# **DART SERVICE INSTRUCTION**

**TO AMEND INSTALLATION INSTRUCTIONS IIN-D117-762 REV. E AND EARLIER AND  
INSTRUCTIONS FOR CONTINUED AIRWORTHINESS ICA-D117-762 REV. 4 AND EARLIER**

**REF. FAA STC: SR01853SE  
REF. TCCA: LOA RDIMS-4374899  
REF. EASA STC: 10017063  
REF. DGAC MEXICO STC: IA-376/2016**

The purpose of this Dart Service Instruction (DSI) is to provide customers with a repair procedure to modify their existing skidtubes to prevent elongation and/or to restore skidtubes with elongated ground handling holes.

**FIGURE 1**  
HOLE ELONGATION

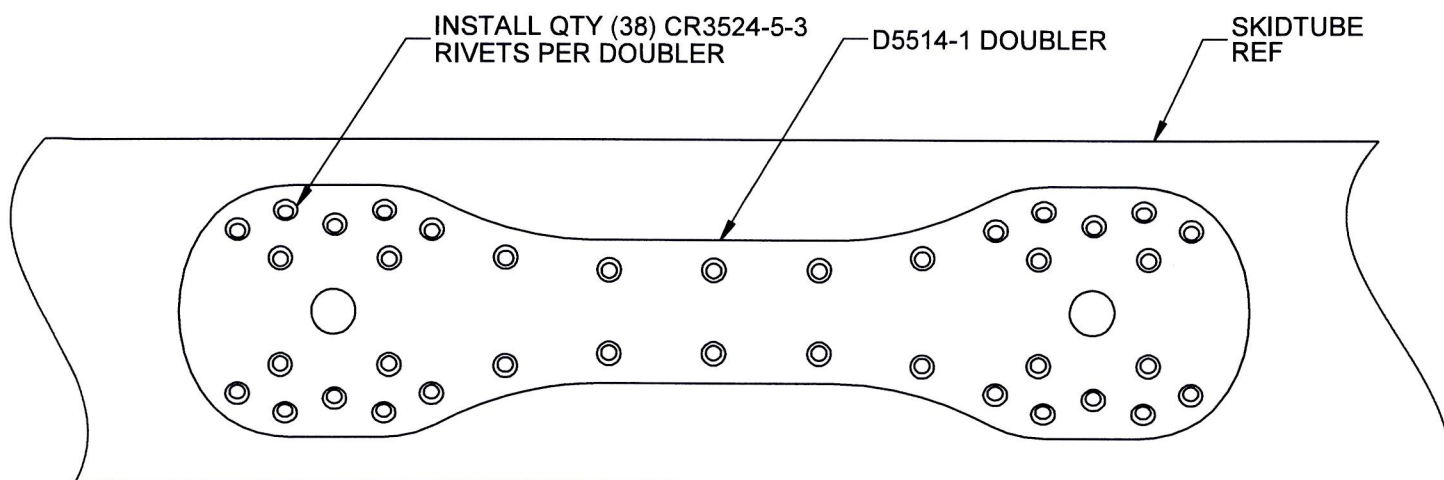
Skidtubes that are acceptable candidates for this repair procedure must have a maximum ground handling hole elongation of 1.05" (26.7 mm) once the hole is cleaned up and deburred. Skidtubes that have a ground handling hole elongation greater than 1.05" (26.7 mm) must be removed from service and replaced. Reference Figure 1 of this service instruction.

**FIGURE 2**  
DOUBLER INSTALLATION  
(SHOWN WITH CROSSBOLT SPACER REMOVED)

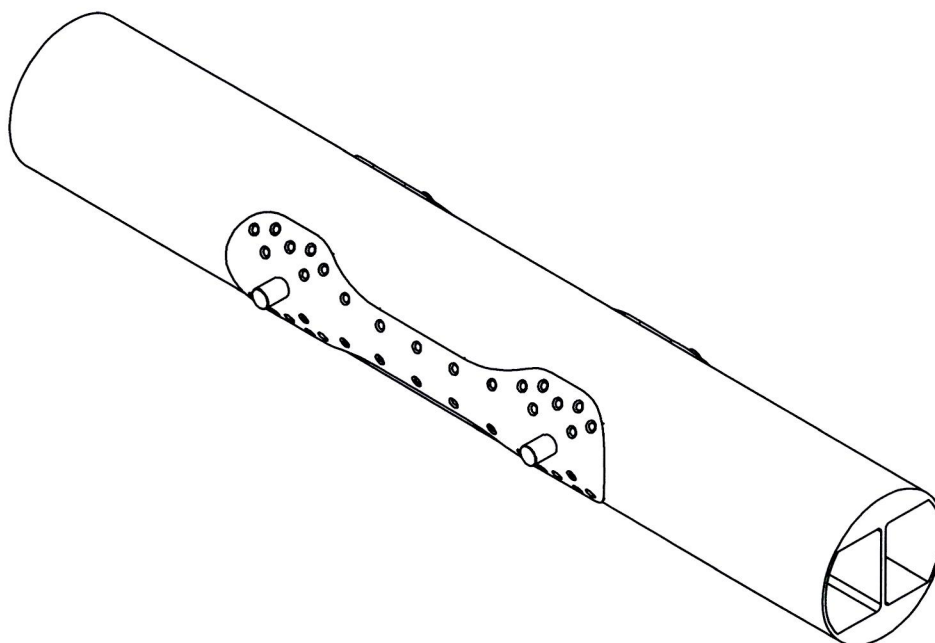
2.5 Ensure that the doubler is properly positioned on the skidtube. Test fit the doubler and D5517-1 Ground Handling Pins (hereinafter referred to as pin(s)). Reference Figure 2 of this service instruction.

- 2.16 Ensure that the doublers and pins remain properly aligned per Figure 2 of this service instruction.
- 2.17 Using CR3524-5-3 Rivets, secure both doublers to the skidtube. Reference Figure 3 of this service instruction
